# **Addendum to the Berths 302-306 APL Container Terminal Project Final Environmental Impact Report**

**APP No. 081203-131**

October 17, 2016

Figure 1 – Approved Expansion Project at Full Buildout as Assessed in Final EIR

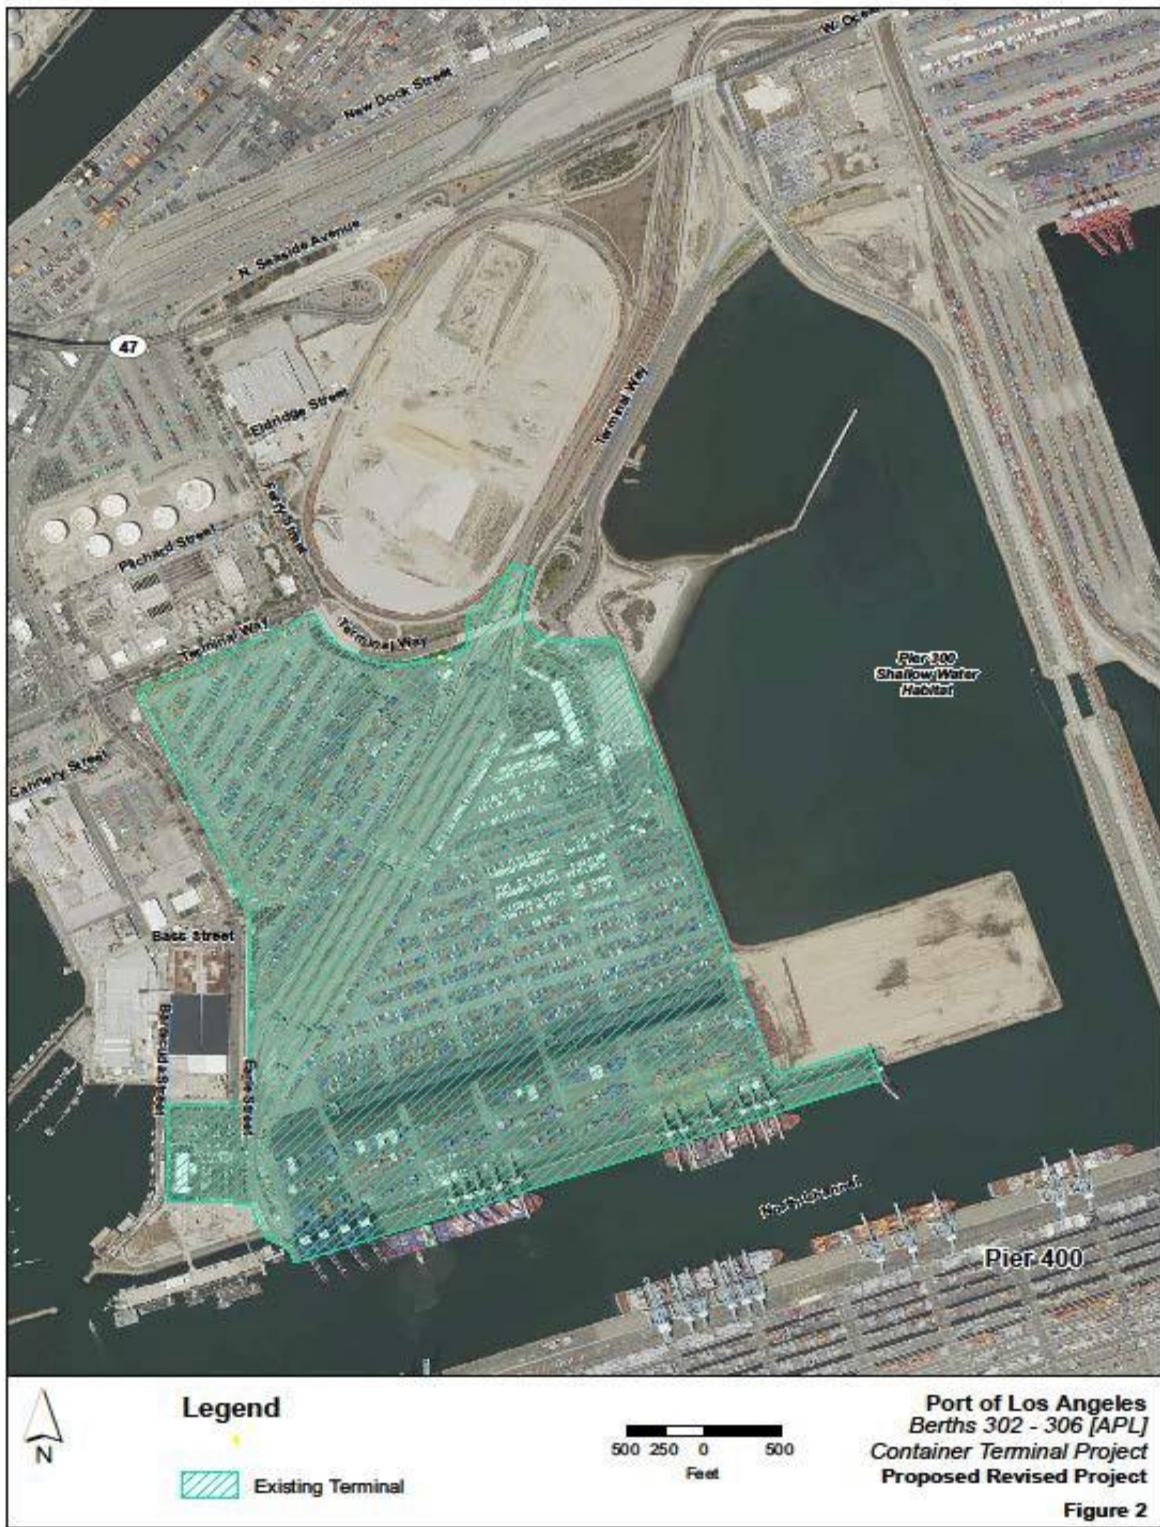
Figures 1 and 2 below highlight the Approved Expansion Project and the Proposed Revised Project.

**Figure 4**  
**Looking Southeast from Deana Dana Friendship Park – Existing Setting**

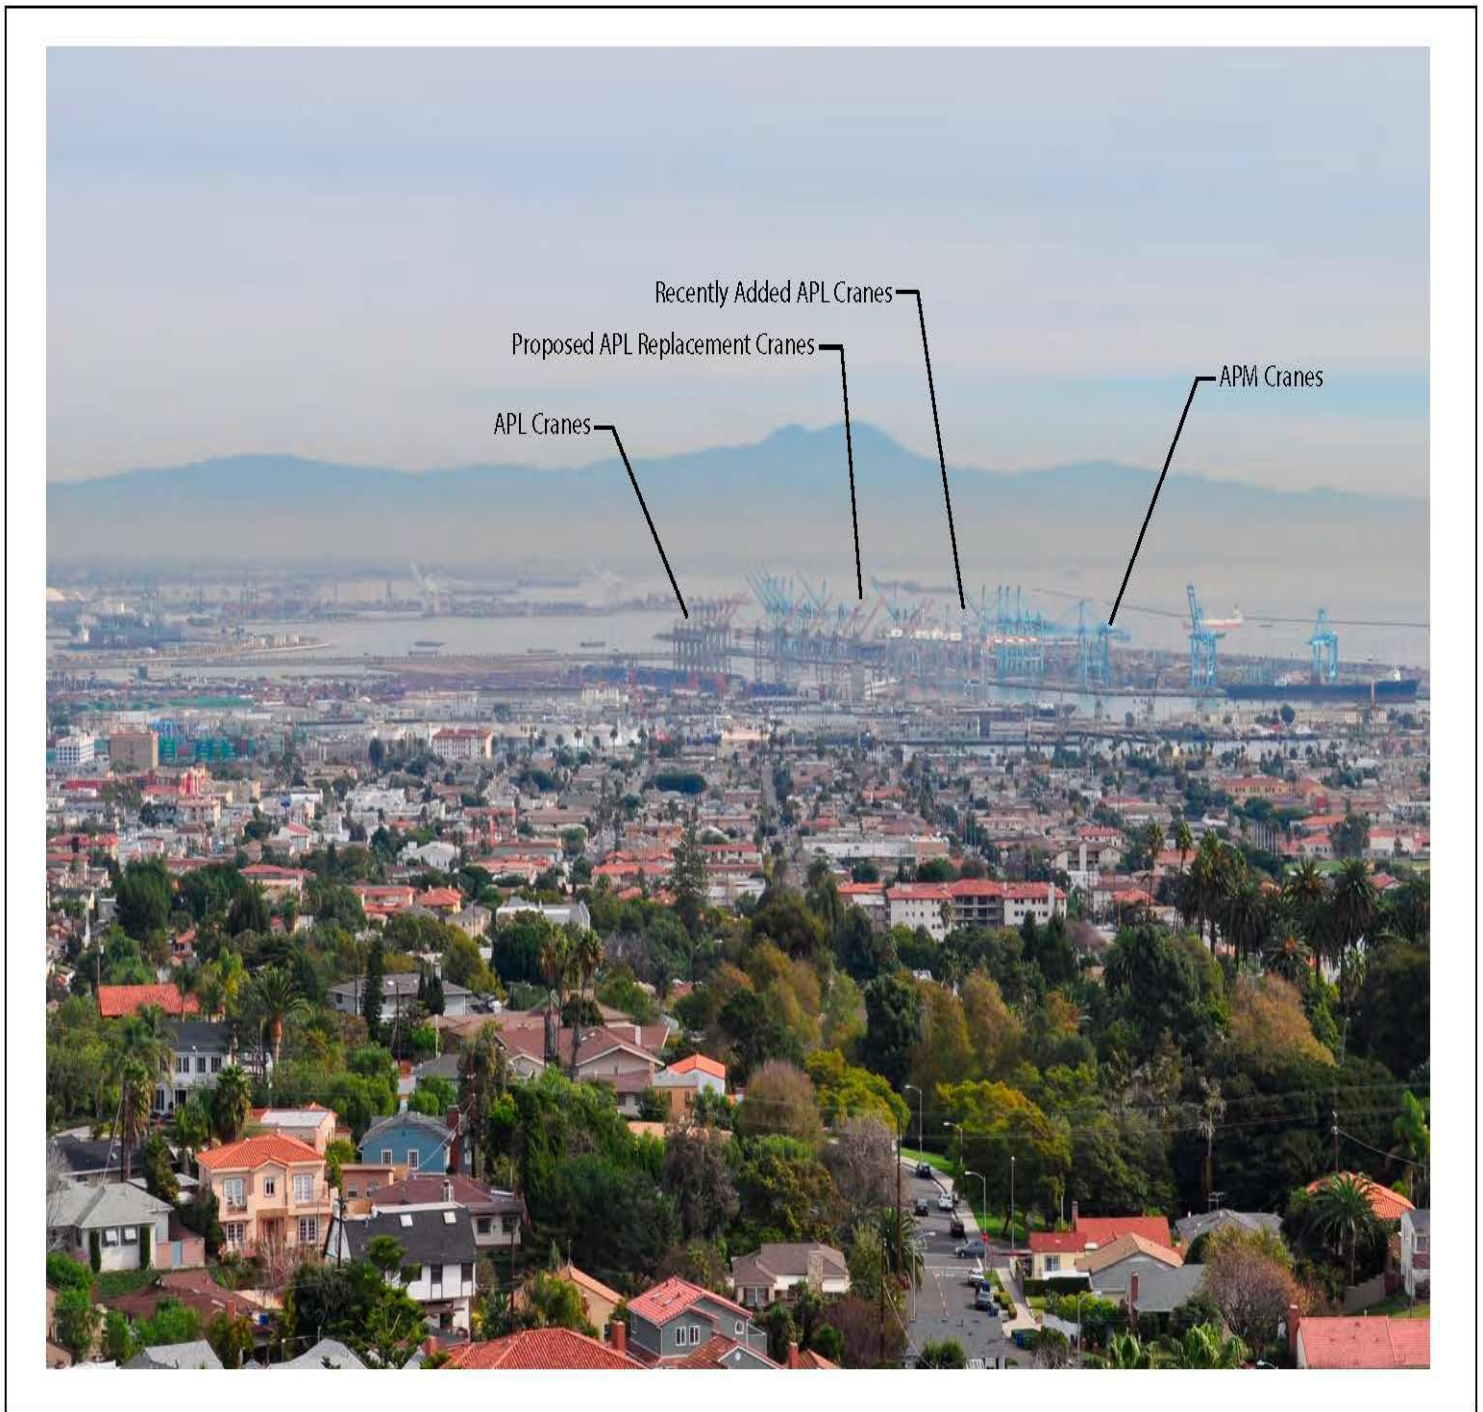
An analysis of existing views was conducted looking Southeast at Deana Dana Friendship Park. Figure 4 shows the viewpoint as it exists today at the time of this Addendum which includes the four cranes installed after the approval of the Final EIR. LAHD contracted with CDM Smith to create the following visual simulations:

As can be seen, there is little difference between the photos showing the existing condition (Figure 4), the Proposed Revised Project (Figure 5) and the originally Approved Expansion Project (Figure 6), other than Figures 4 and 5 show less cranes than what was contained in the Approved Expansion Project.
